WORKING DRAFT HFCV GTR - 8-11-09

Work assigned on page 20:

Japan will provide a risk assessment to justify all three following components for each container: main shut off valve, a container check valve (=container non-return valve) and a container safety valve (= pressure relief device)

Analysis of the Collision Direction Based on Traffic Accident Data (2005 Japan)

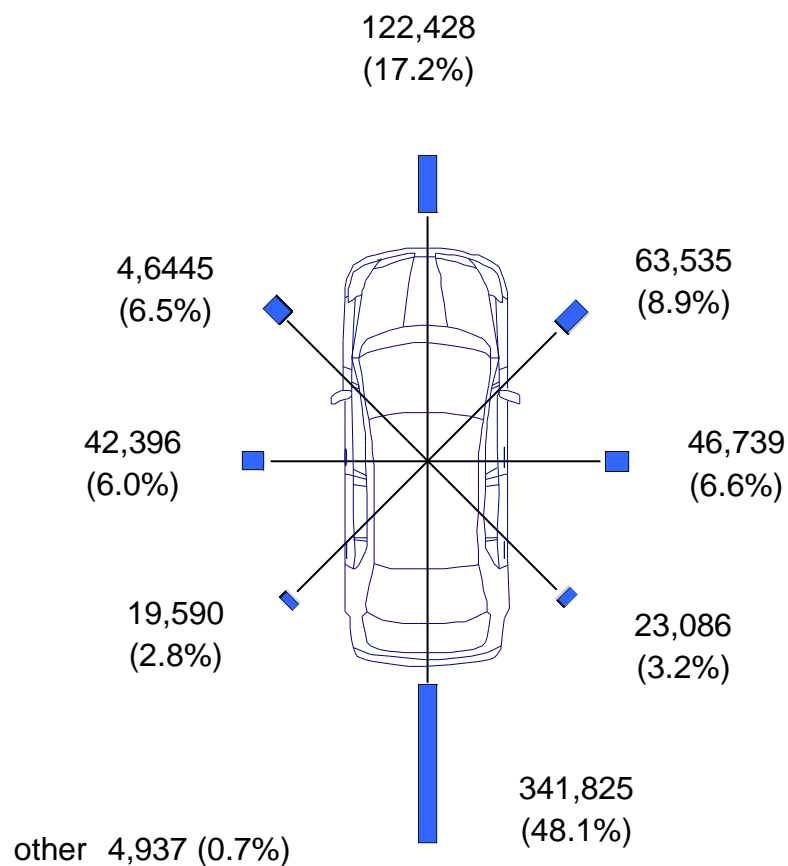
In Japan, fuel leakage in crashes is tested in four directions: front, offset, side, and rear. The front, offset, and side crash tests are conducted primarily for the purpose of occupant protection (fuel leaks are checked at the same time), whereas the rear crash test is conducted solely for the purpose of fuel leak check. Comparison of impact directions between these tests and actual traffic accidents that occurred in Japan in 2005 shows that the tests cover 80% of the actual directions, but not all.

Impact Directions in Tests and Actual Traffic Accidents

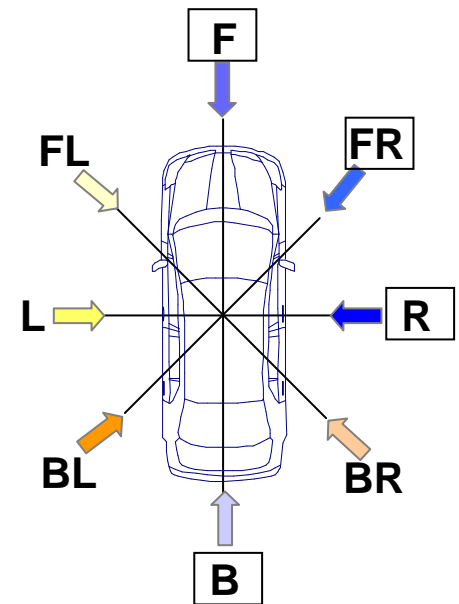
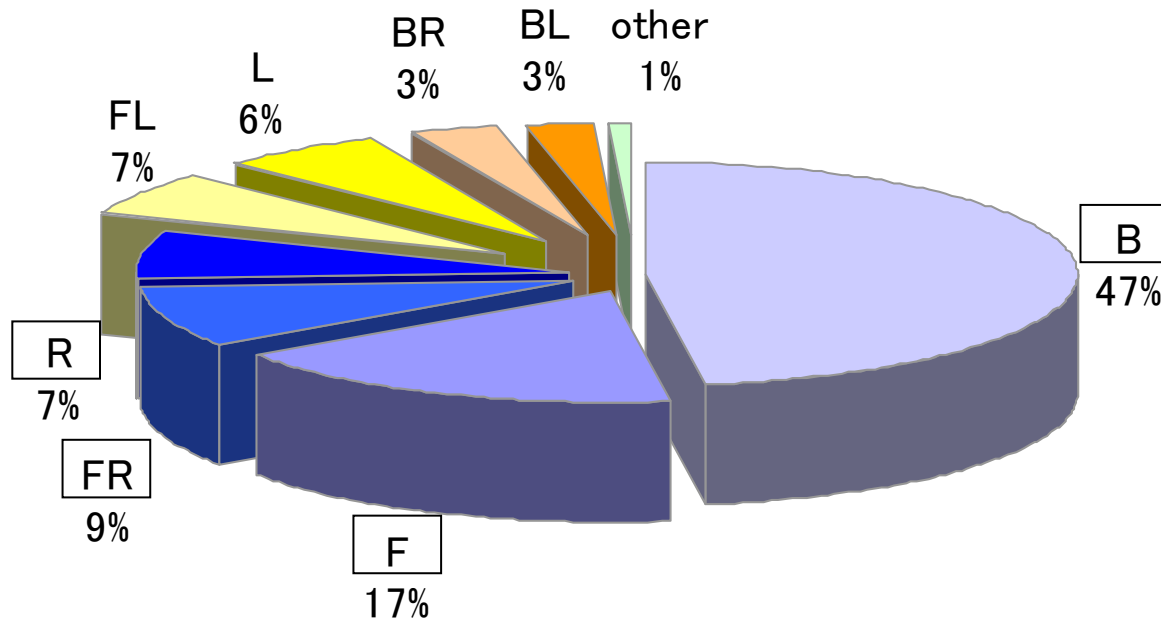
Fuel leakage in crashes is tested in the three directions (front, offset, and side), plus the fourth direction (rear), as indicated by squares below. Comparison of directions between these tests and actual traffic accidents shows that the tests cover 80% of the actual directions, but not all.
